✓  
QUESTION REQUEST FORM  
ENVY NRC 2004 INSPECTION

Feedwater Nozzles

**Subject: Vermont Yankee Nuclear Power Station  
License No. DPR-28 (Docket No. 50-271)  
Alternative Feedwater Nozzle Inspection**

Subject: Feedwater Spargers - Response to NRC's Request for Additional Information

FEEDWATER NOZZLE TEMPERATURES  
NOZZLE A

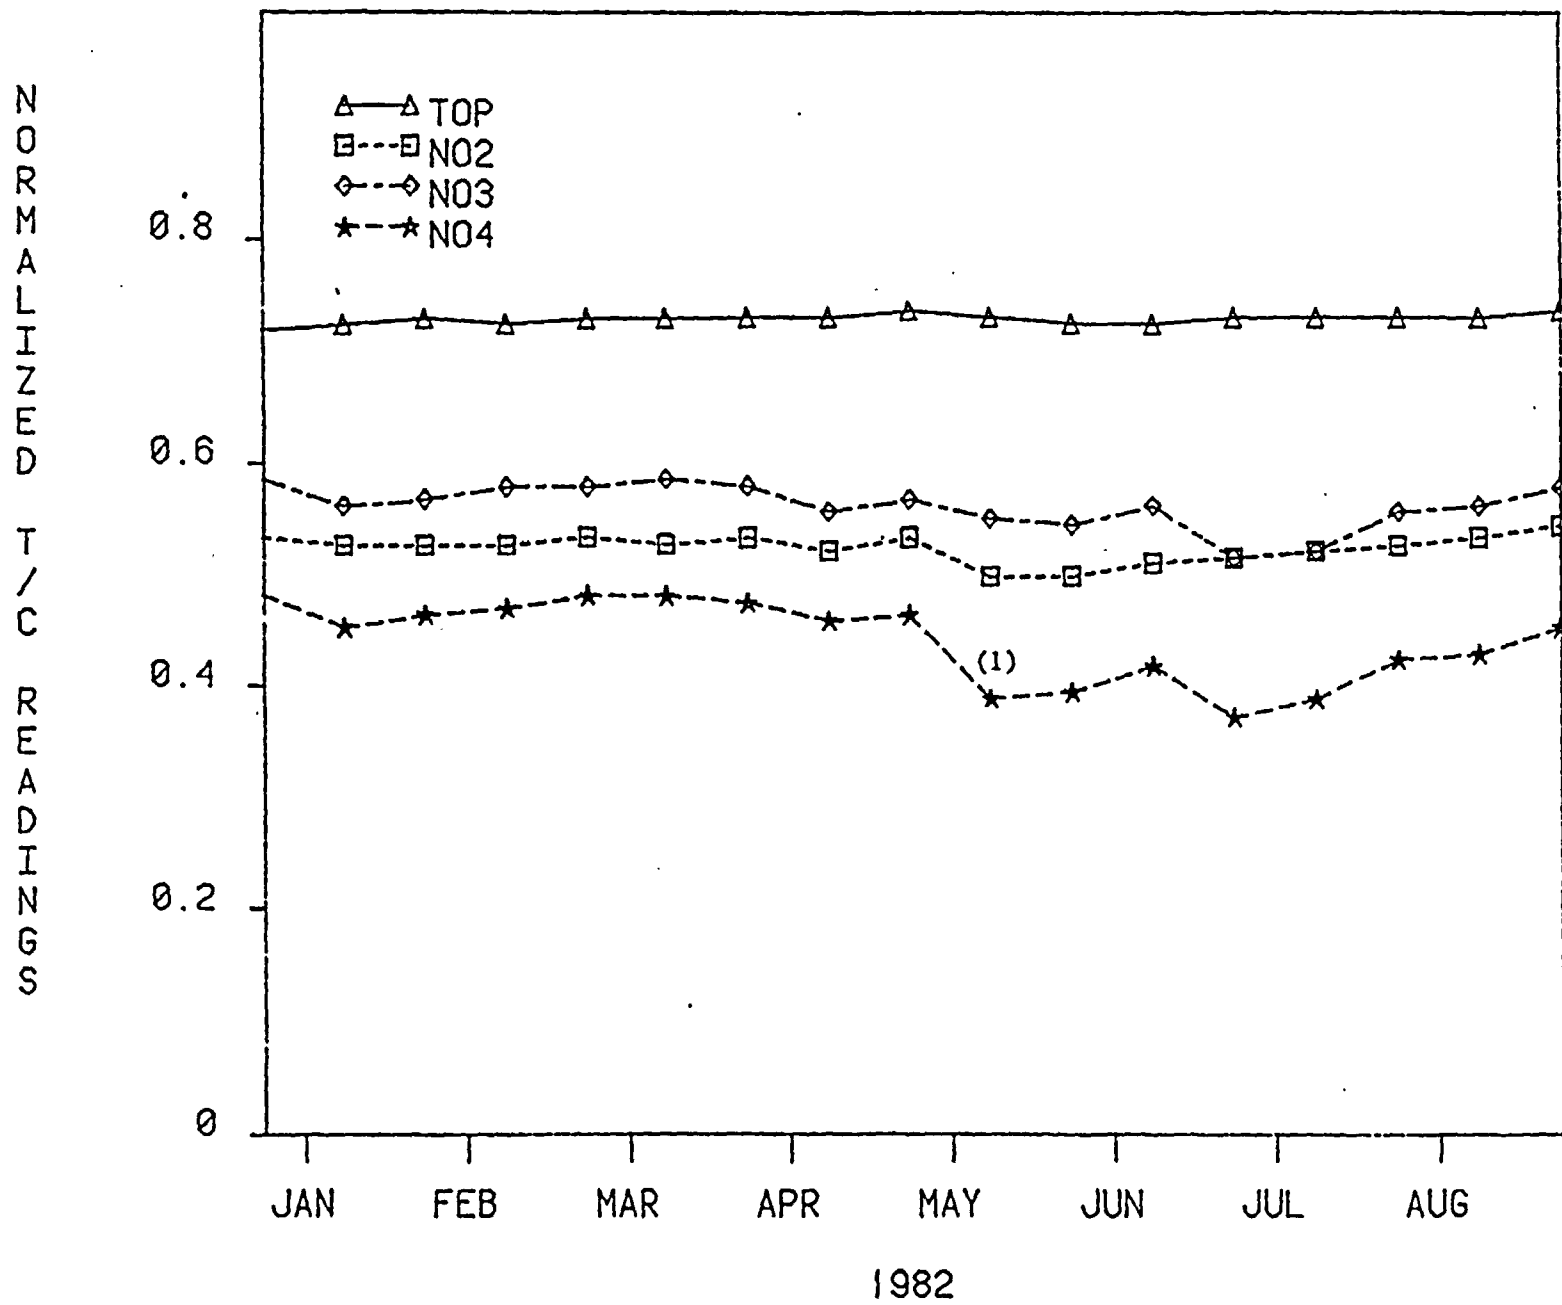
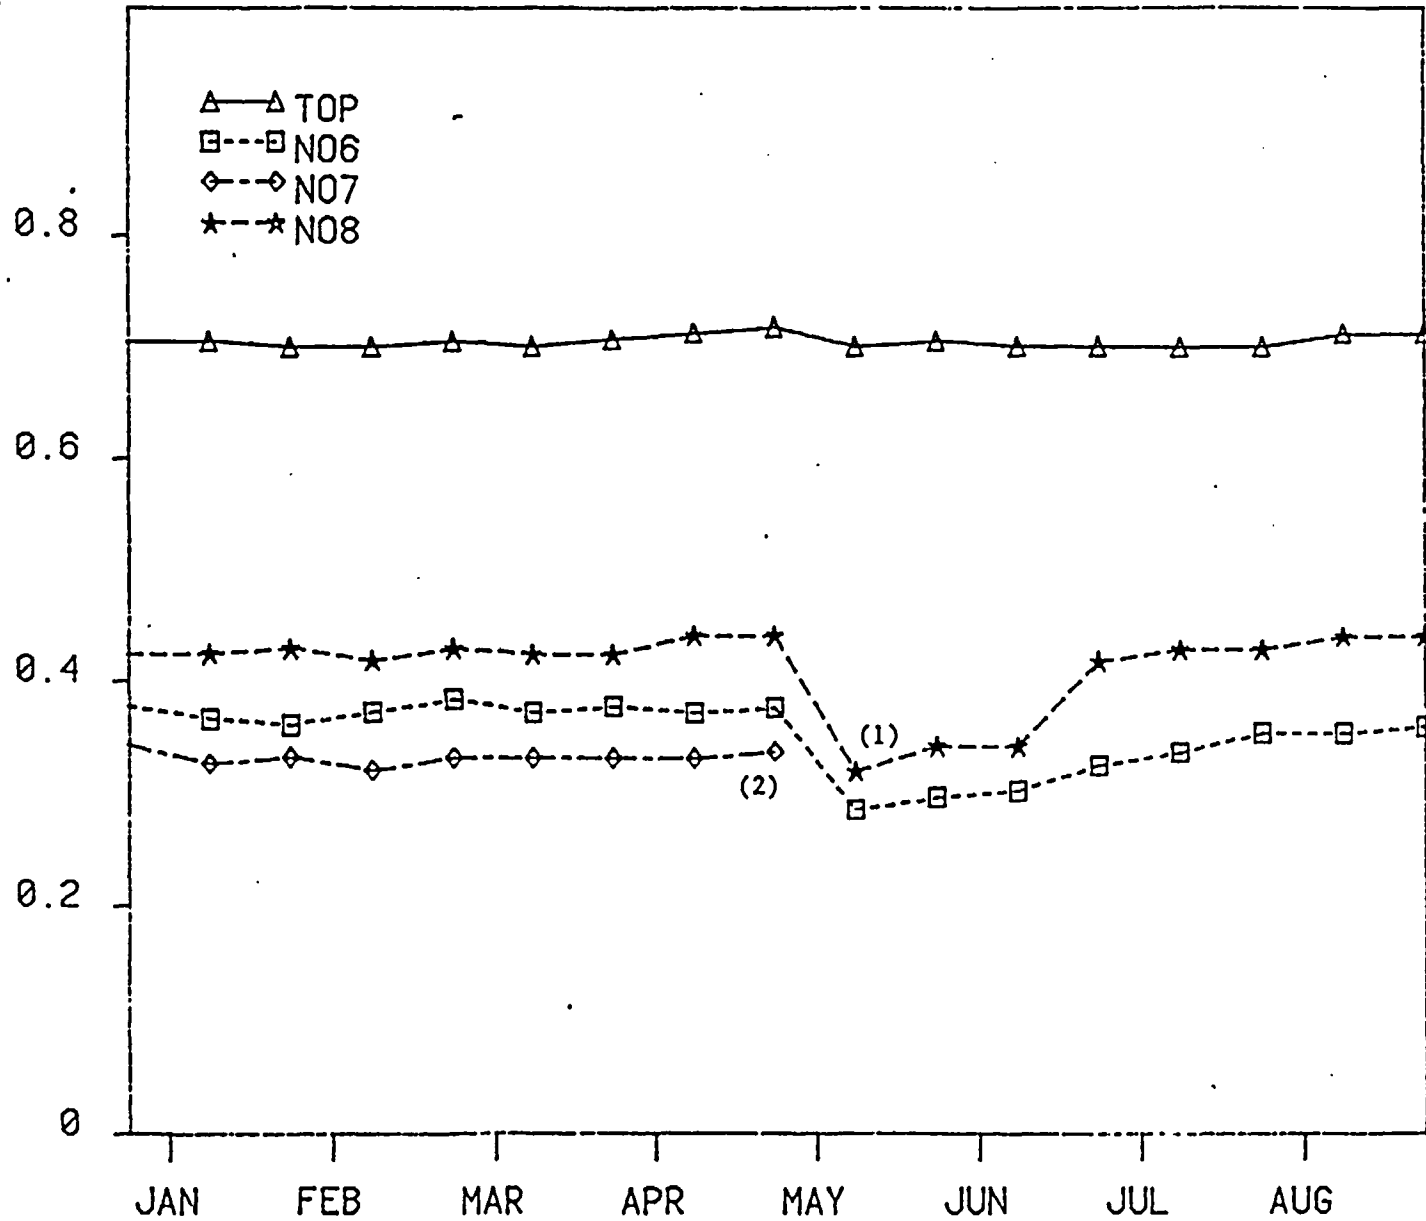
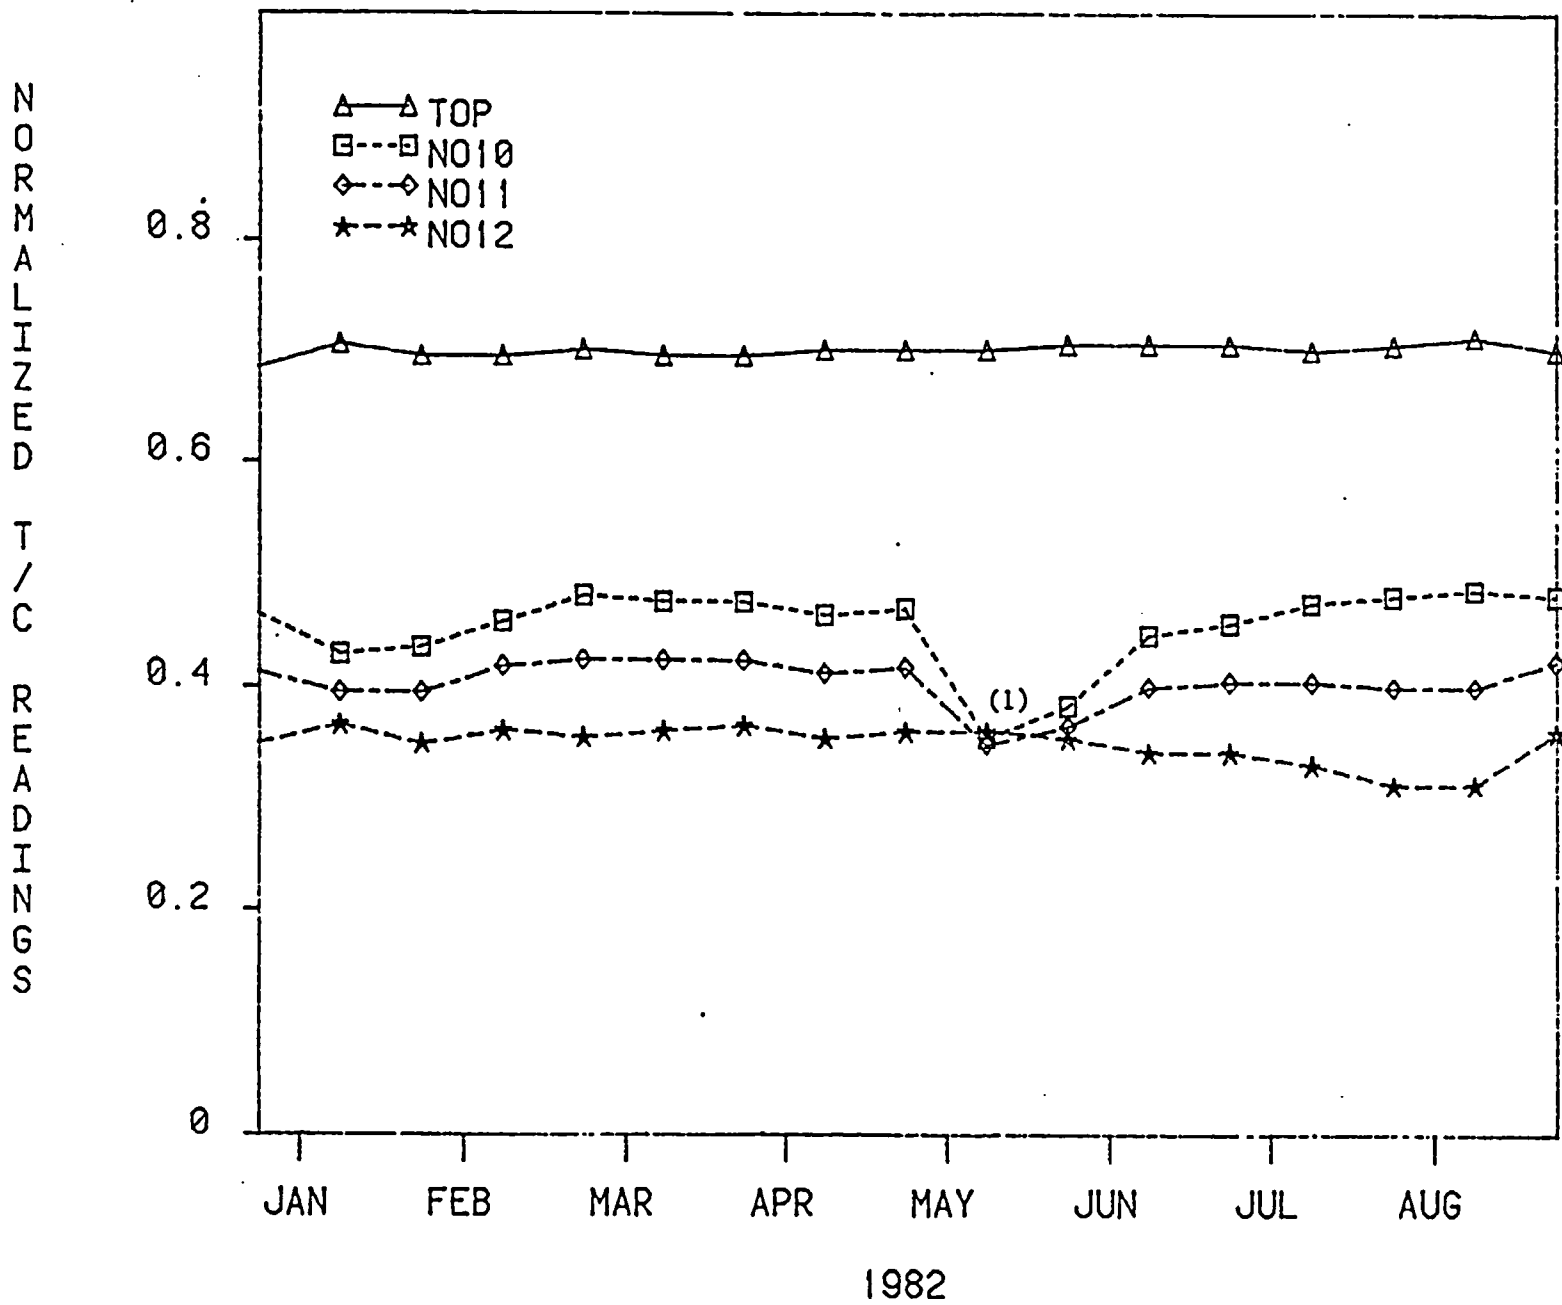
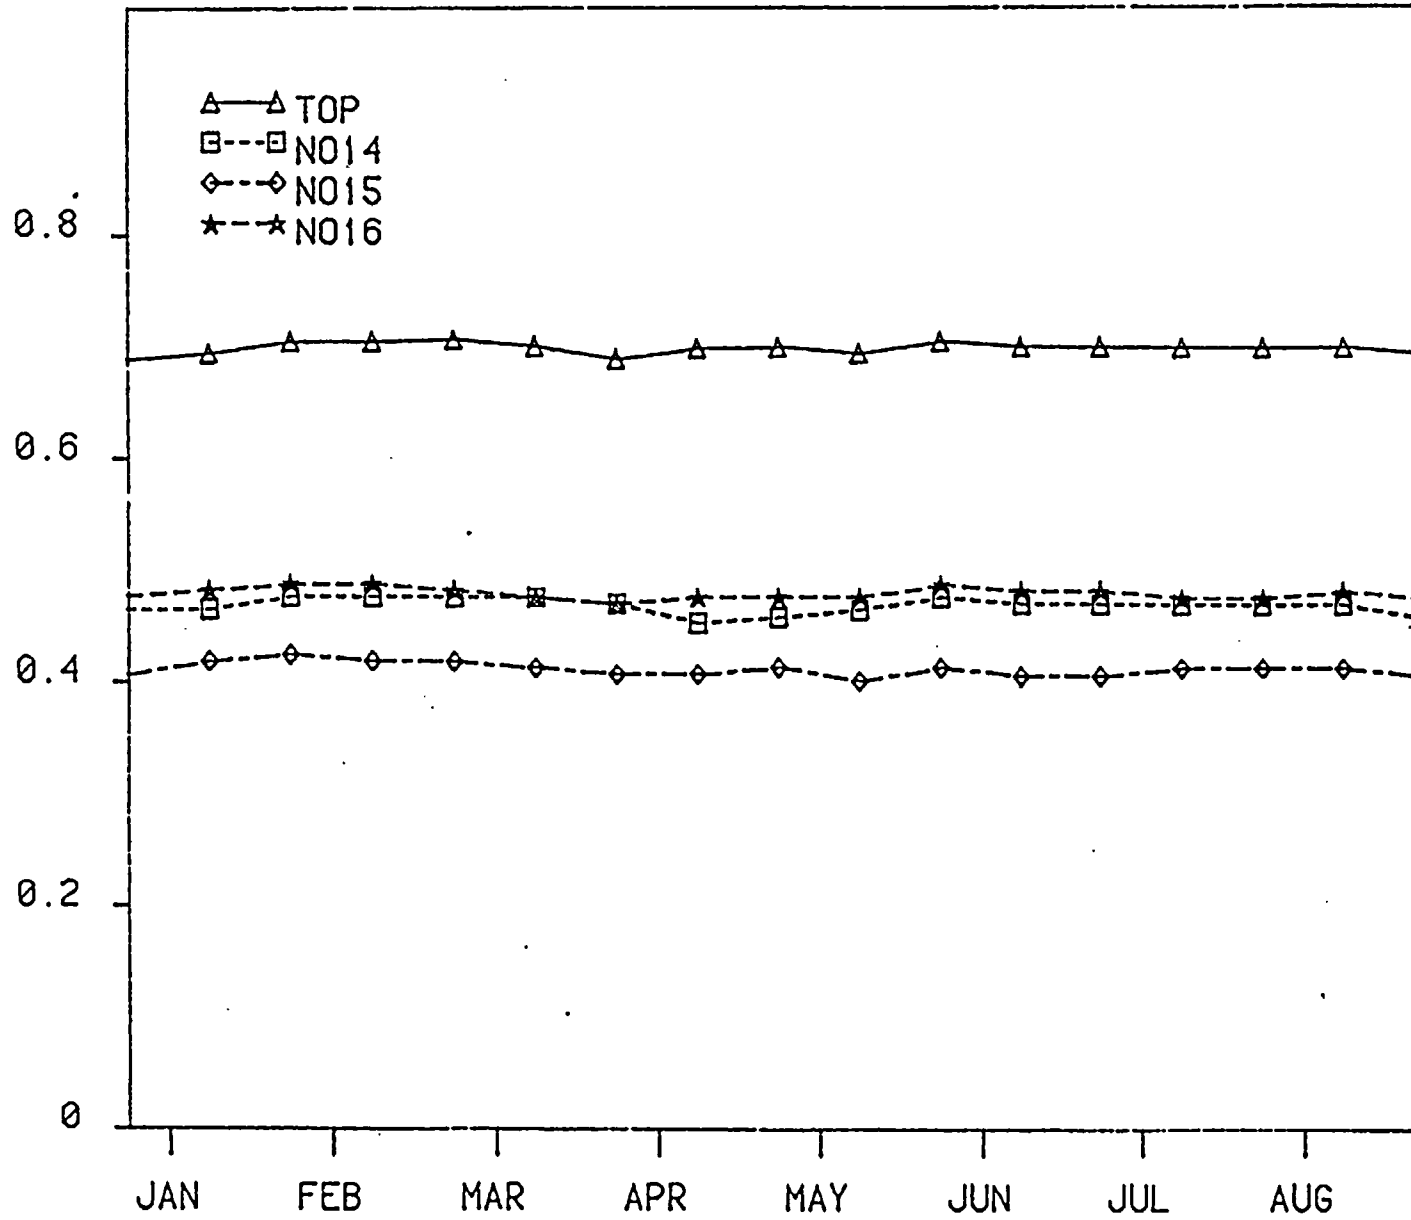
Certify as correct (or identify any errors) in writing to the NRC in the temperature data listed in Table I of Enclosure 3.

Certify as correct (or identify any errors) in writing to the NRC in the plant cyclic data shown in Figure 1 of Enclosure 3.

In lieu of providing raw temperature data which can be misleading due to the varying plant conditions at the time temperatures are recorded, we are enclosing (Attachment 2) the normalized temperature data which has been tracked since startup to mid-August.

Since Commitment (4) of Reference (b) is addressed to normalized temperature limits, the curves provided will serve as our baseline data.

The information, as presented in Figure 1 of Enclosure 3 is accurate as of April 1982. However, since we originally supplied you with the cyclic data via Reference (c), we have had three additional startup/shutdown cycles.
